## NOTICE OF NON-PERFORMANCE

On October 8, 2025, Energy Safety conducted an inspection of PacifiCorp's WMP initiatives in the vicinity of the city of Klamath River, California. The inspection report is enclosed herewith. Energy Safety found the following deficiencies:

# INSPECTION REPORT

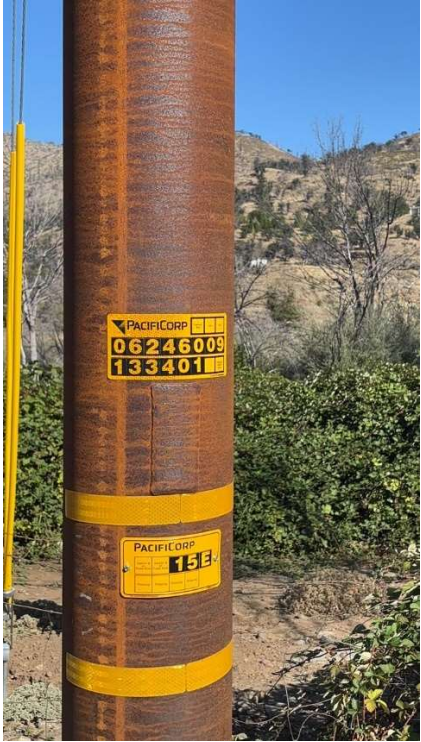
1. The inspector did not observe covered conductor installed at the Pole ID 06246009133401 along the east side span to the next Pole ID 06246009.0133400.
2. The inspector observed bare conductor at the Pole ID 06246009133401 along the east side span to the next Pole ID 06246009.0133400.

**Structure ID:** 0624600.9133401

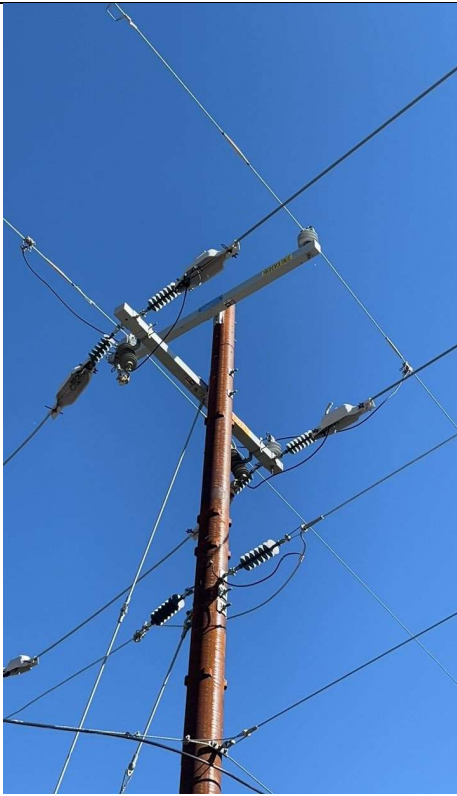
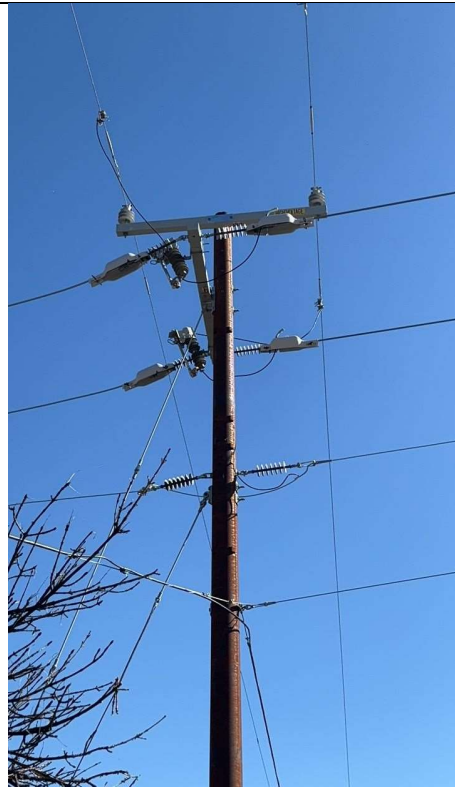
**IA1Img1:** No covered conductor installed on the east side span of the pole.

**IA1Img2:** No covered conductor on the east side span of the pole, bare conductor is observed.

**IA1Img3:** No covered conductor installed on the east side span along Klamath River Road to next pole with Pole ID 06246009.133400.

**IA1Img4:** The next pole, Pole ID 06246009.133400 with no covered conductor installed.
